MECKLENBURG COUNTY GROUNDWATER & WASTEWATER SERVICES
APPLICATION FOR A RESIDENTIAL SITE IMPROVEMENT PERMIT/ CONSTRUCTION AUTHORIZATION FOR AN ON-SITE WASTEWATER SYSTEM, NEW WELL INSTALLATION, OR REPAIR OF EXISTING WELL

SOIL/SITE EVALUATION for ON-SITE WASTEWATER SYSTEM

Re: Application for improvement permit for:
Property Site: W. Dixie Drive
Health Department file number: **7765B**

Sketch of Soil Evaluation Locations

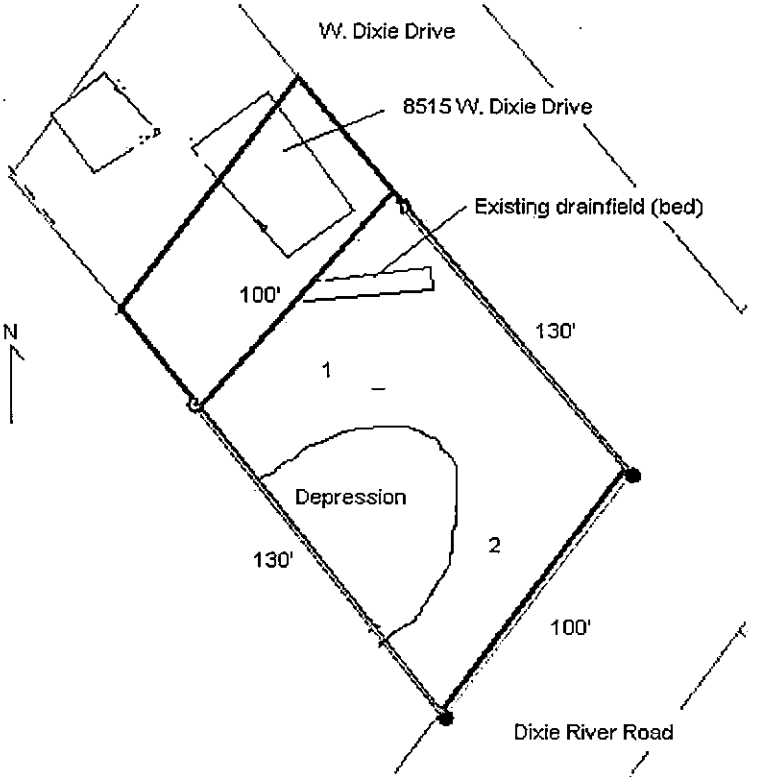
100% repair, drainfield for 8515 W. Dixie Drive almost completely on new proposed lot. Need soil investigation with pits if improvement permit is pursued any further.

Sketch of Soil Evaluation Locations

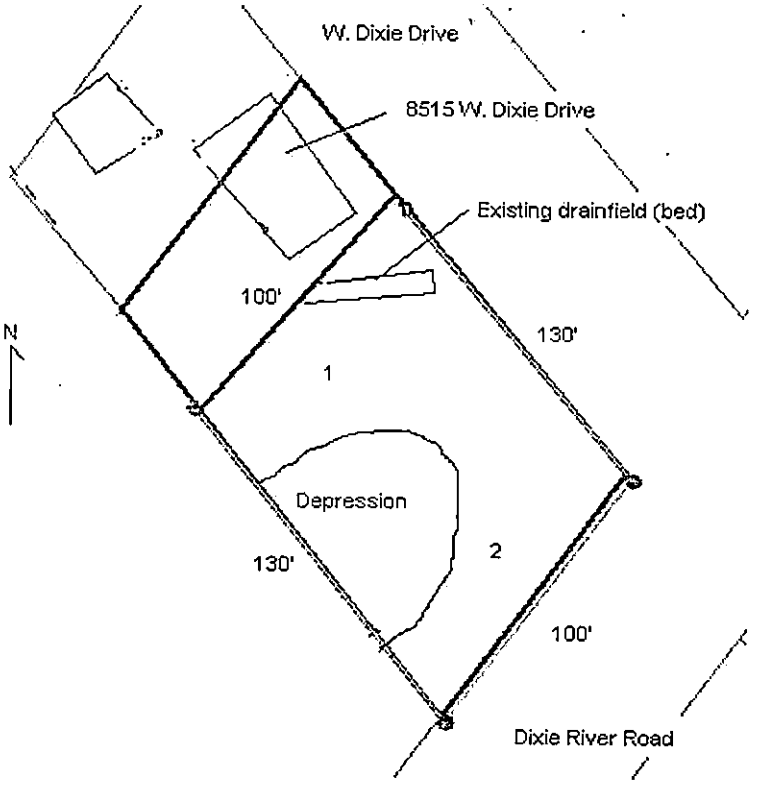
100% repair, drainfield for 8515 W. Dixie Drive almost completely on new proposed lot. Need soil investigation with pits if improvement permit is pursued any further.
